Subject: POWER WINDOW DOES NOT WORK PROPERLY AND/OR ABNORMAL NOISE WHEN OPERATING	Bulletin No.: 09-007/26
	Last Issued : 01/30/2026

This bulletin supersedes the previously issued bulletin(s) listed below. The changes are noted in Red text.

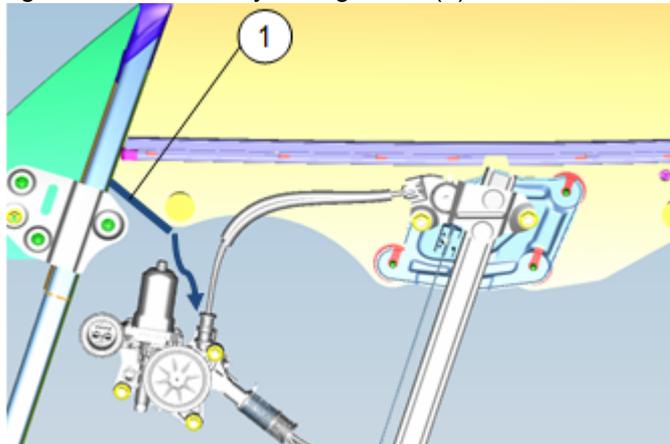
Some vehicles may exhibit the power window(s) not working properly (window does not move or has fallen into the door) and/or making an abnormal noise while operating the power window switch. This may be caused by the cable of the power window motor being damaged from water entry through area (1) of the front beltline molding.

Convertible Top: To eliminate this concern, the shape of the door glass **has been** modified during mass production to prevent water entry to the power window regulator.

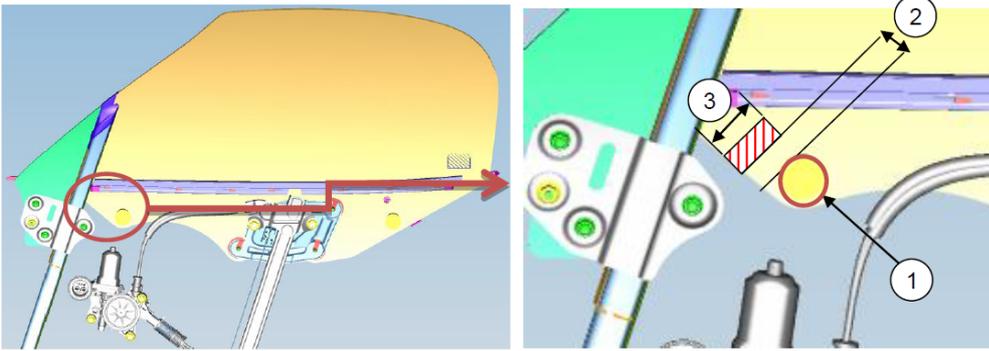
CAUTION: DO NOT ALLOW THE REGULATOR CABLE TO UNWIND. It is very difficult to wind the cable around the drive wheel if it does unwind. Hold the drive wheel in place before removing the zip tie and installing it to the power window motor.

Retractable Hardtop:

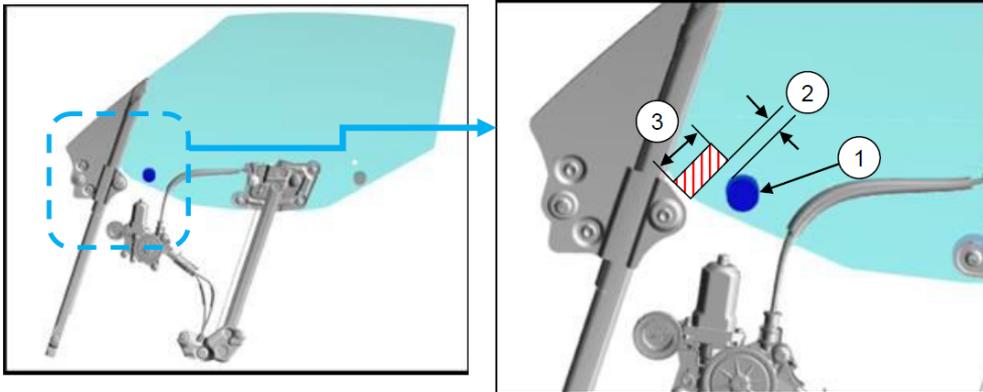
- b. Transfer the power window motor to new regulator according to the instructions on MGSS (POWER WINDOW REGULATOR DISASSEMBLY/ASSEMBLY).
- c. Clean and degrease around the area of the glass where the rubber seal will be applied using 3M Adhesion Promoter 06396 (or equivalent) and let it dry for 5 minutes.
- d. Apply the rubber seal 15 mm from glass stopper (1).

- Rubber Seal Application Area (2): 15 +/- 5 mm from Glass Stopper(1)
- Rubber Seal Length after application (3): 25 +/- 5 mm

- 1) Cut the rubber seal into two 50 mm length strips and stack them together.

- 2) Peel off the half of protective foil to confirm its center.

- 3) Apply the seal to the position shown in step d so that the edge of the glass is wrapped.
